Plan Change 7 – Technical Planning and Infrastructure Report

Rotokauri North Proposed Private Plan Change 7

Report on technical planning and infrastructure matters relevant to Hamilton City Council

Report Author: Paul S Ryan, Principal Planner, City Planning Unit, Hamilton City Council

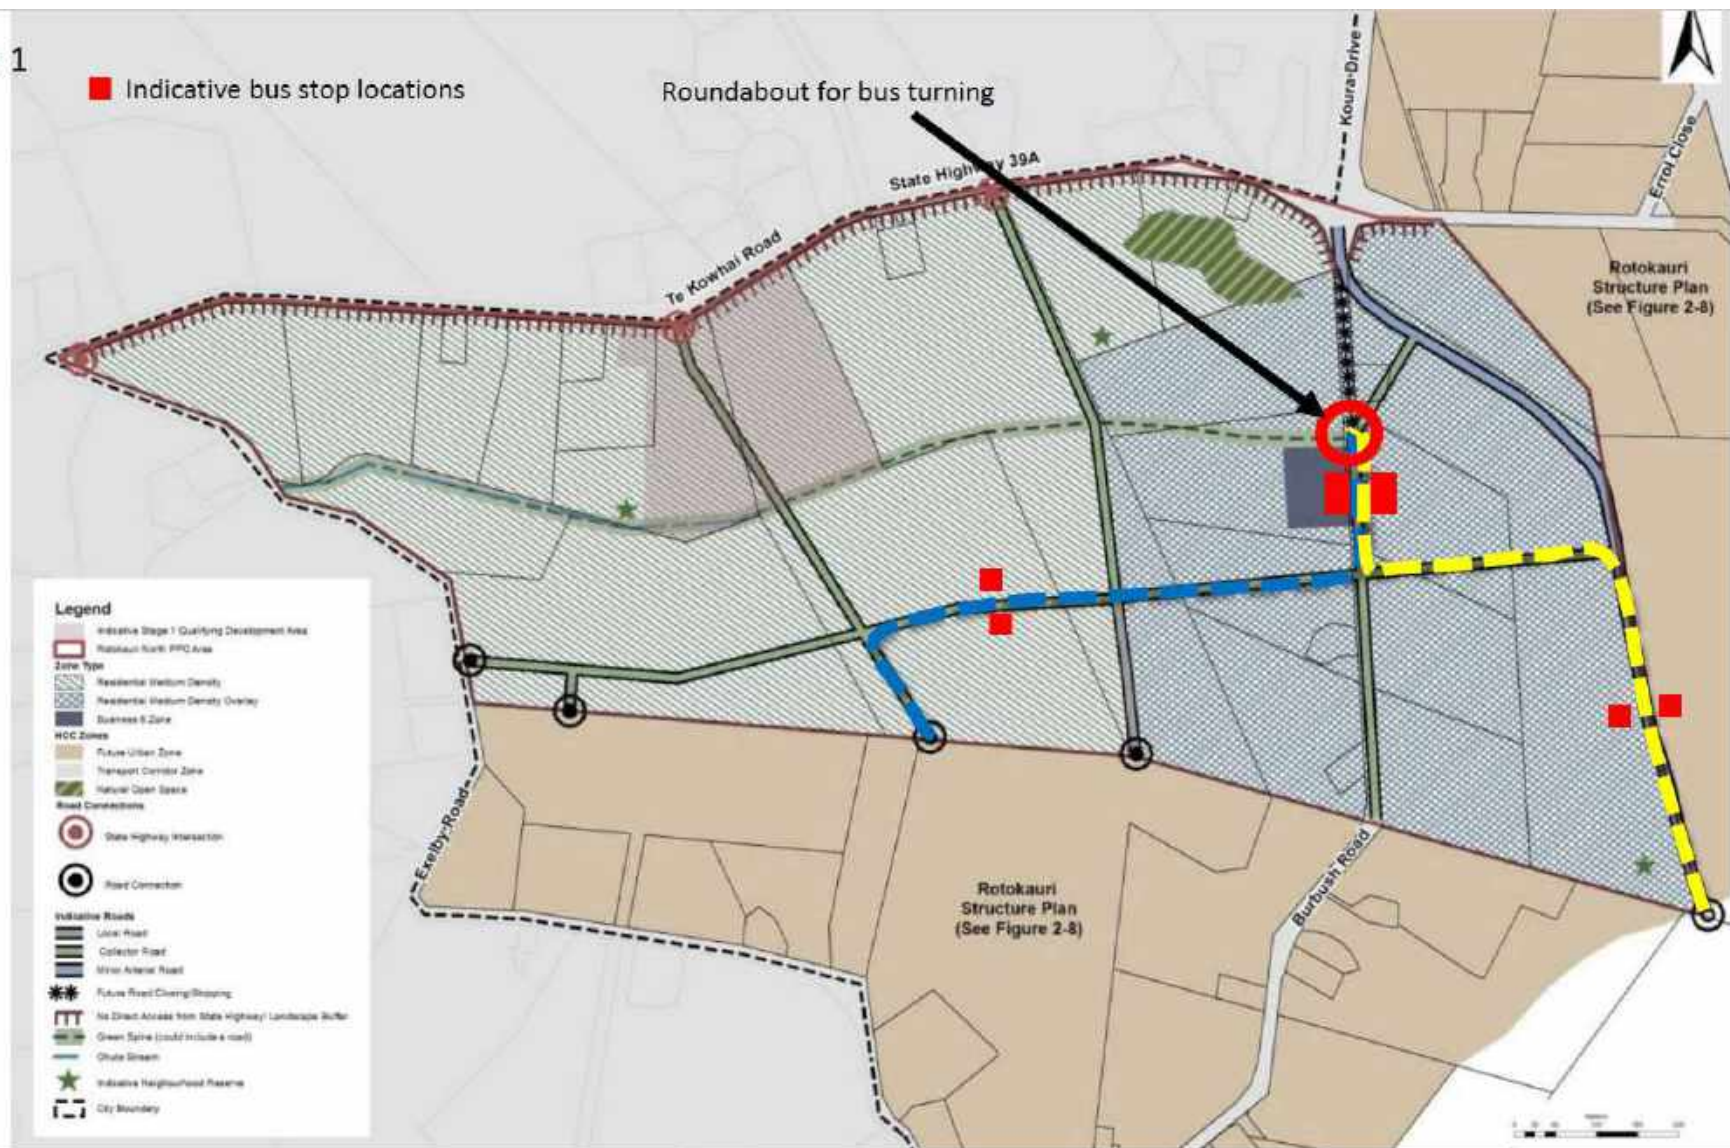
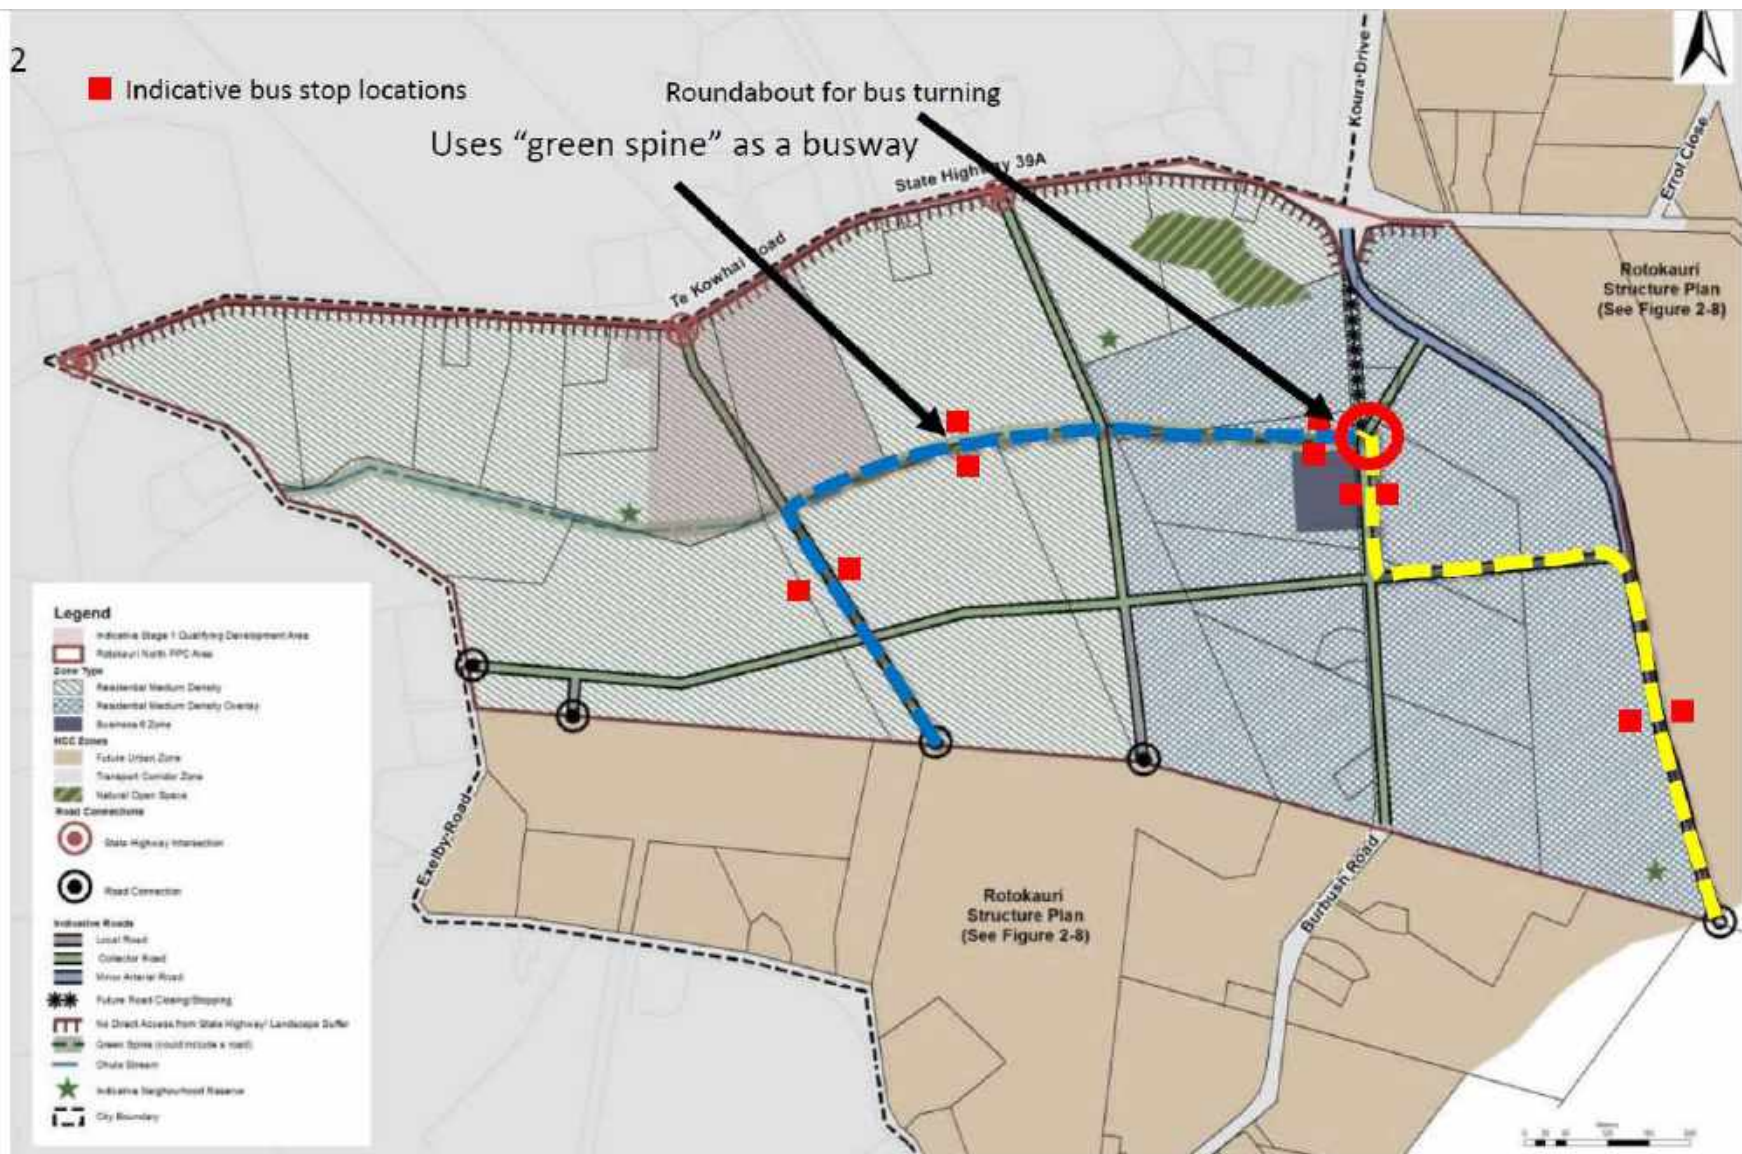
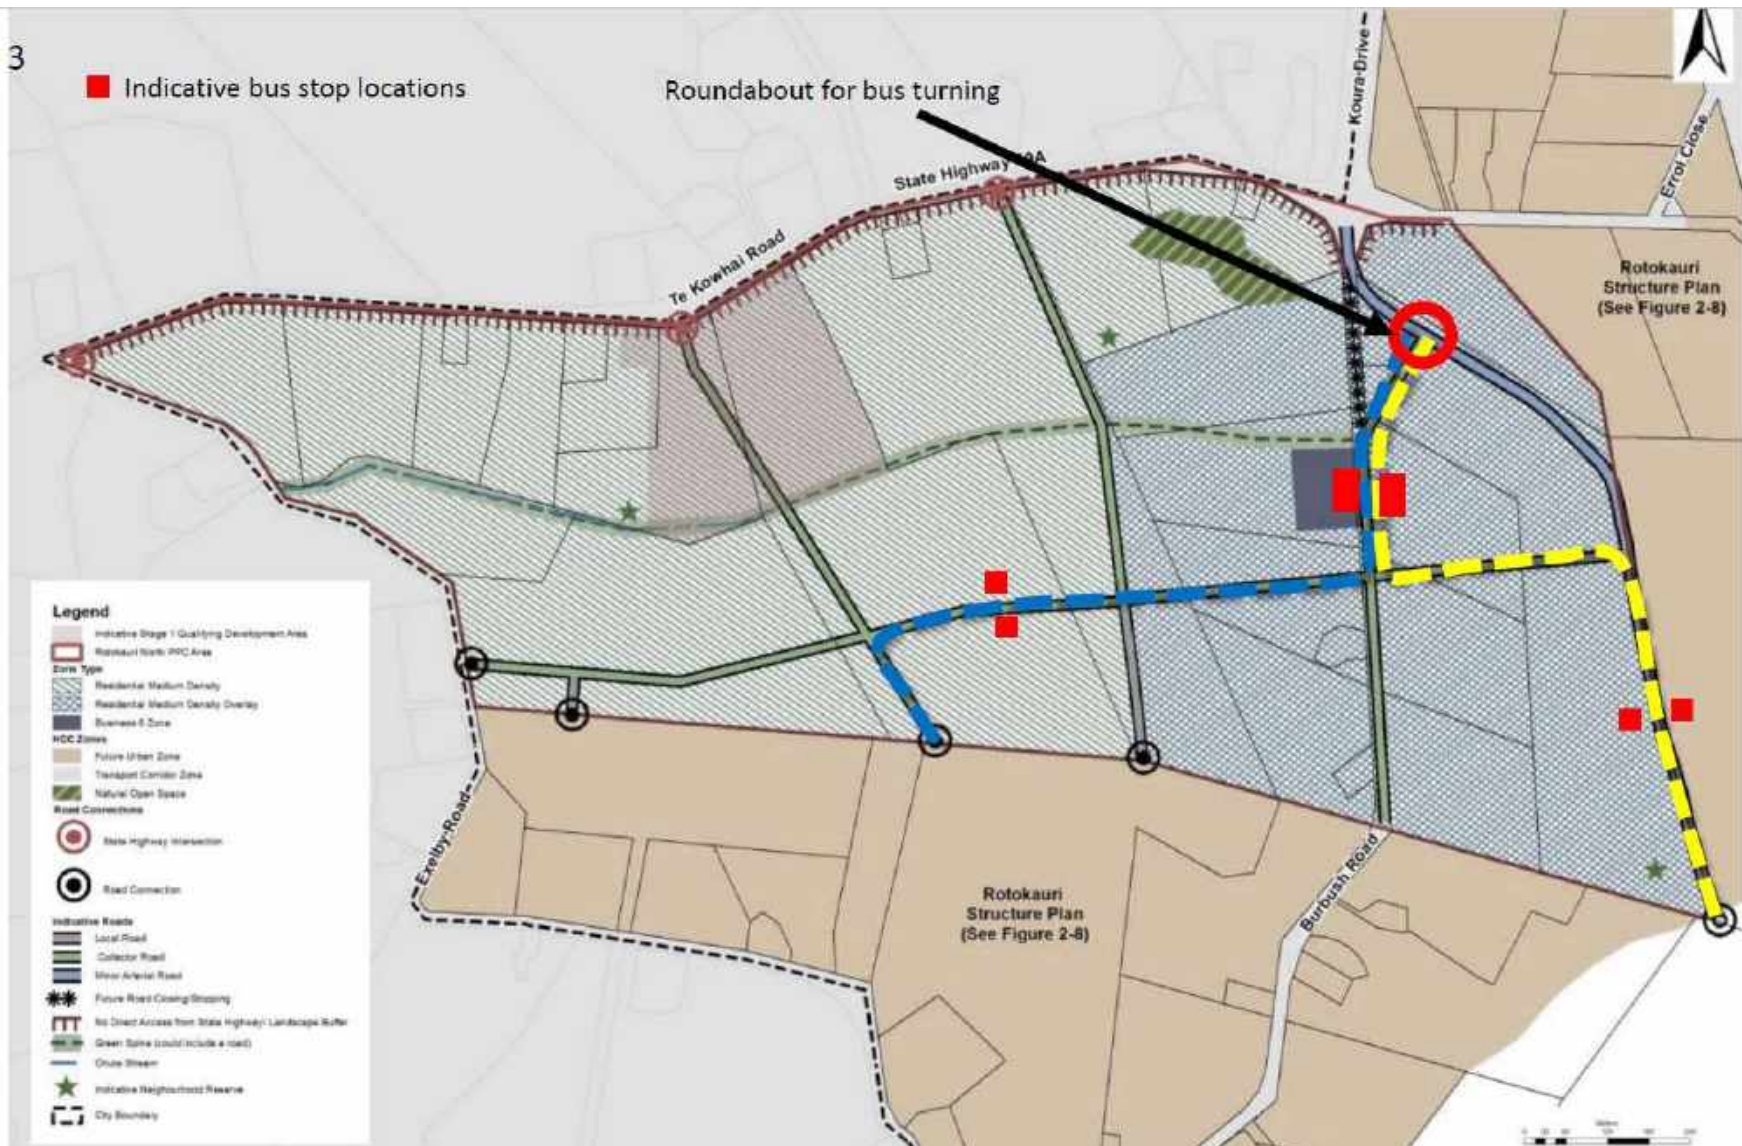
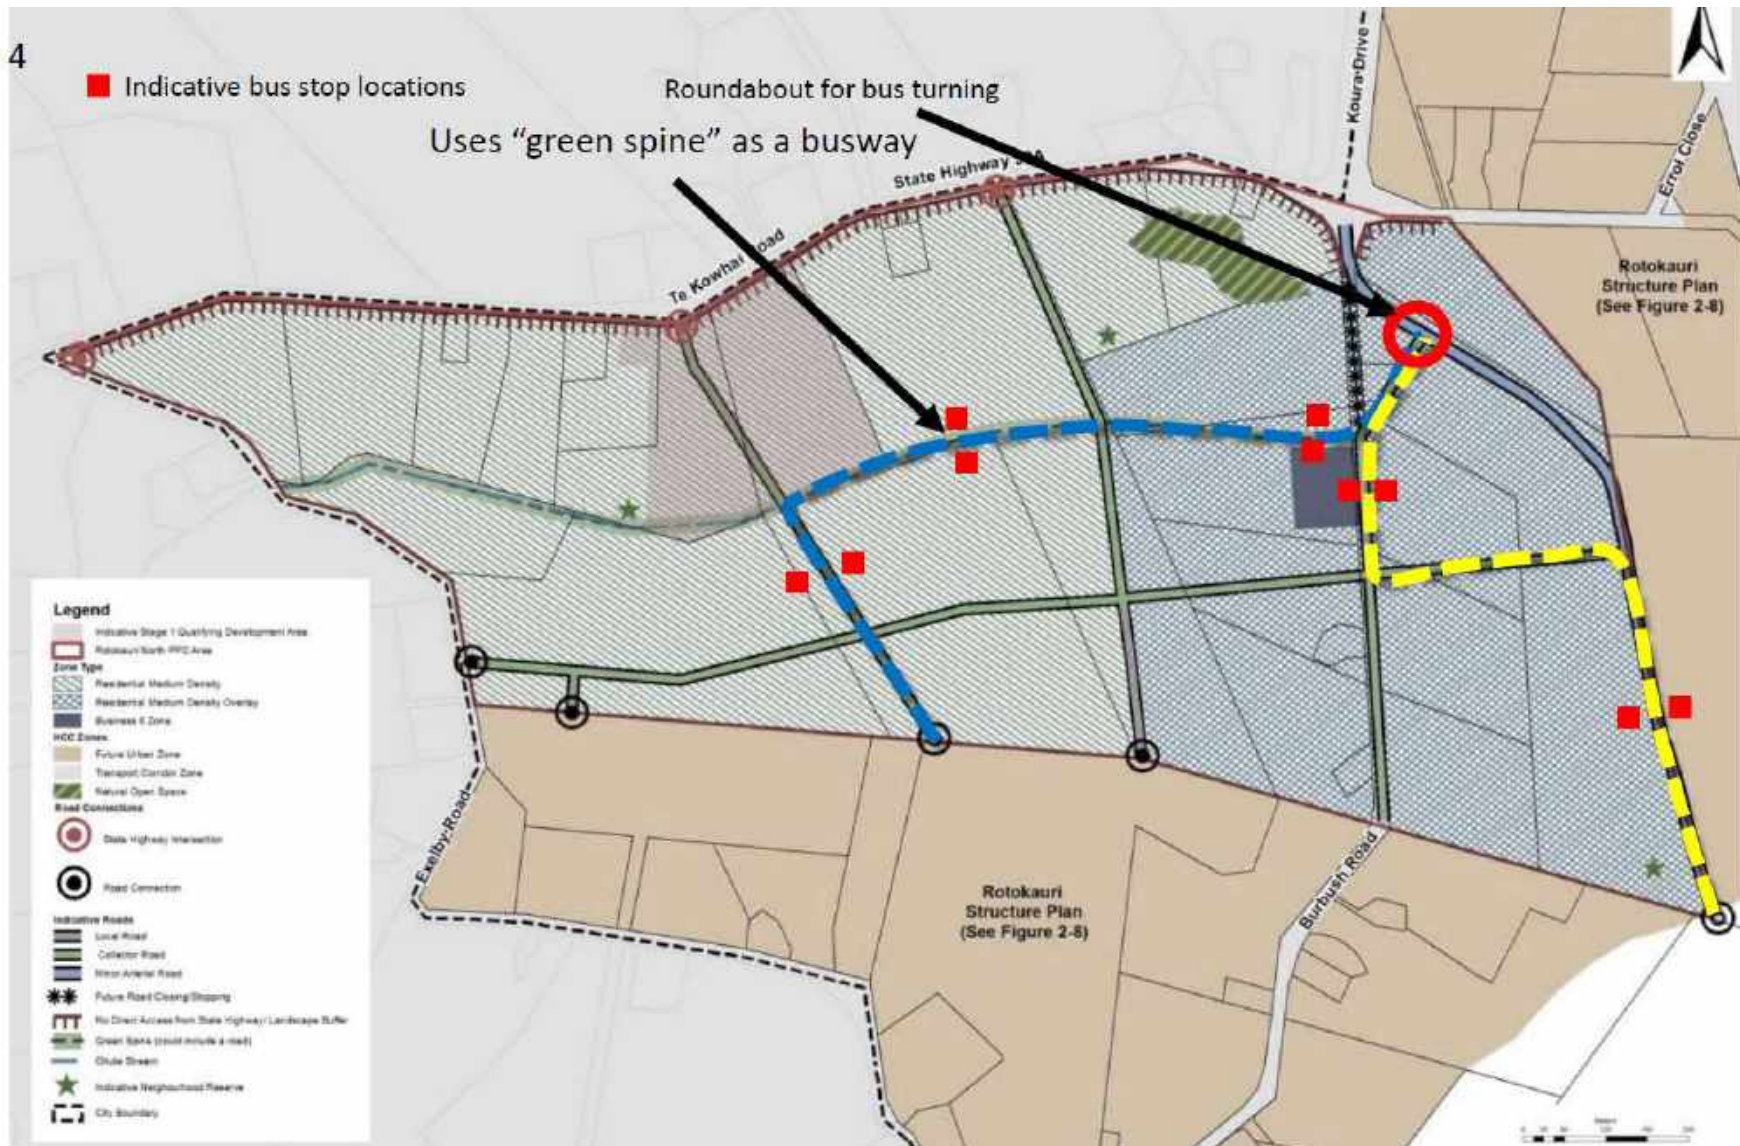
On 19 February 2021, Andrew Carnell, Team Leader – Network Planning and Performance, Waikato Regional Council provided Figure 3 in Appendix 5. He advised that the Regional Council has yet to determine the preferred option for Rotokauri North; this is still a “work in progress”. He also provided detailed maps of 4 options for servicing Rotokauri North – see Figures 4 to 7 in Appendix 5.

It is recommended that, prior to the hearing, the Requester, Waikato Regional Council and Hamilton City Council work together to determine the best public transport option for Rotokauri North and show it on Figure 2-9C.

It is recommended that, prior to the hearing, the Requester, Waikato Regional Council and Hamilton City Council work together to determine which is the best public transport route option for Rotokauri North and show it on Figure 2-9C. See s11.13.1.

Proposed Figure 2-9D - Watercourse Classification

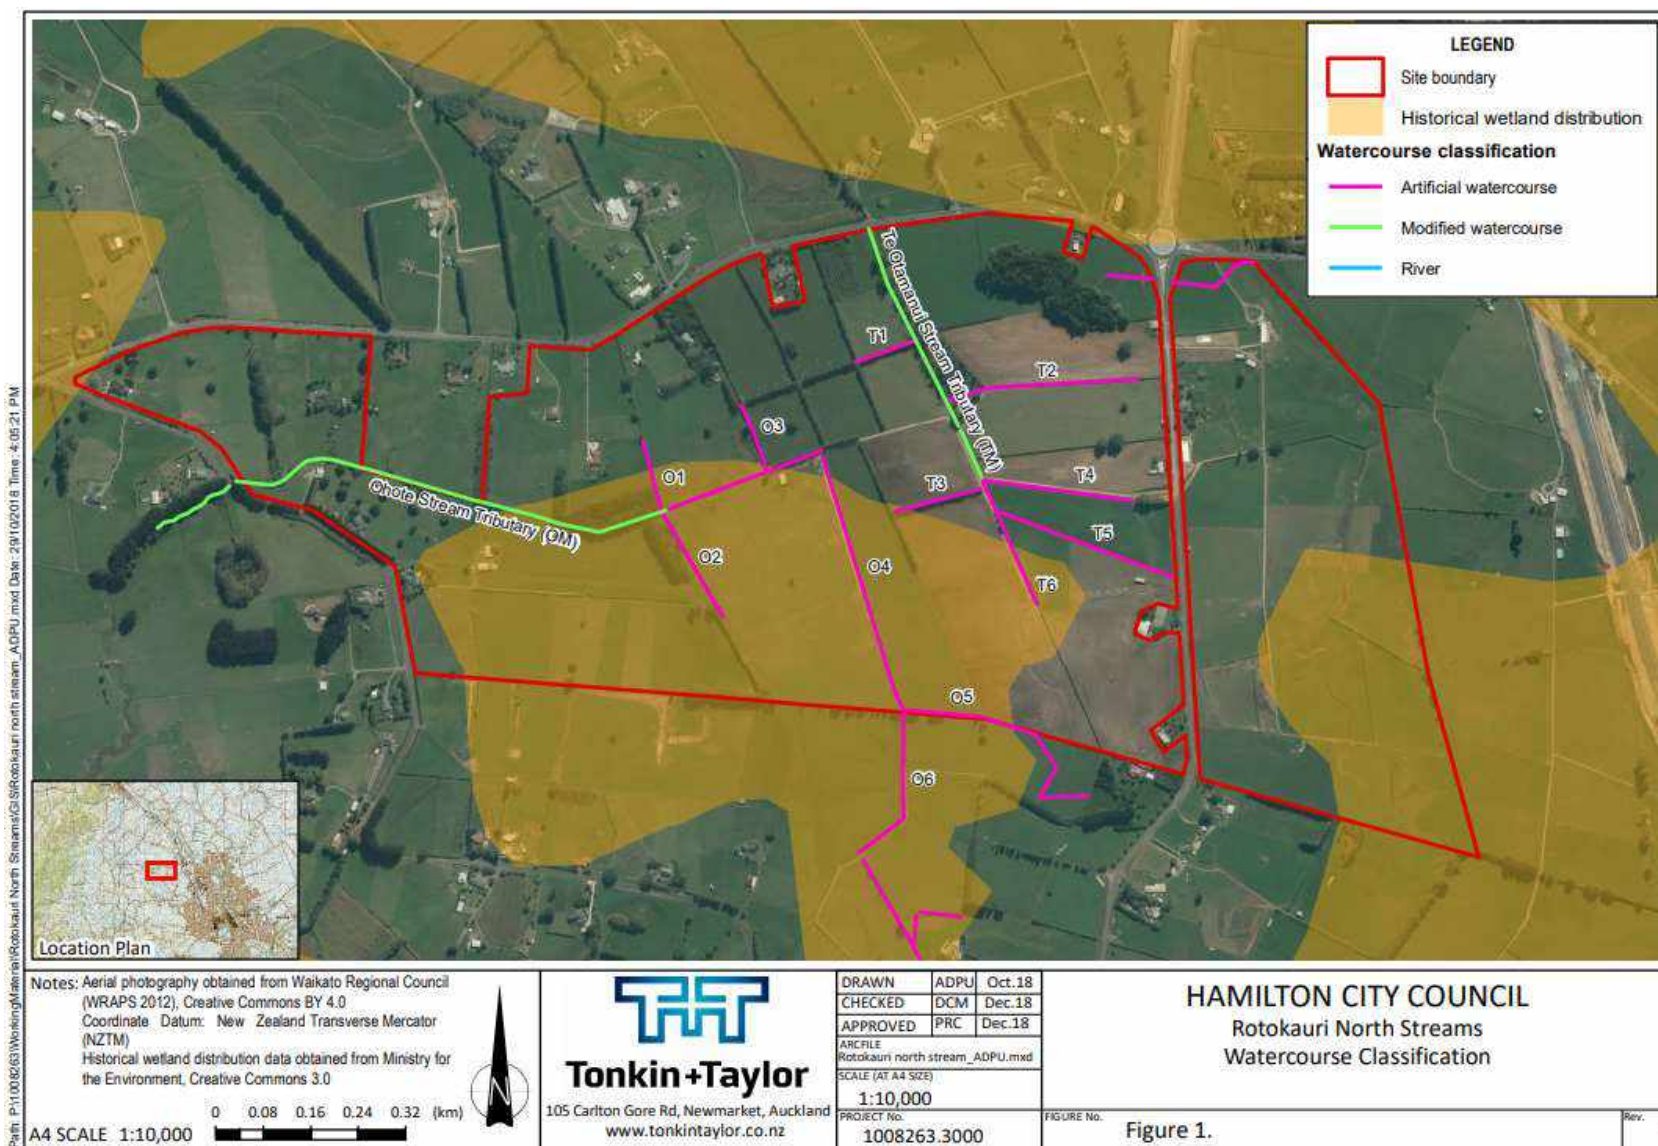
Recommended Rule 1.2.2.24 d ii D above refers to a new figure, Figure 2-9D. It is recommended that the Tonkin & Taylor drawing¹⁰² showing watercourse classifications be adopted as Figure 2-9D and included in PC7. This figure is included as Appendix 1 to Attachment 11 to the Plan Change Request and is attached as Appendix 6 to this report.

It is recommended that the Tonkin & Taylor drawing showing watercourse classifications, which is included as Appendix 1 to Attachment 11 to the Plan Change Request, be adopted as Figure 2-9D and included in PC7.¹²²
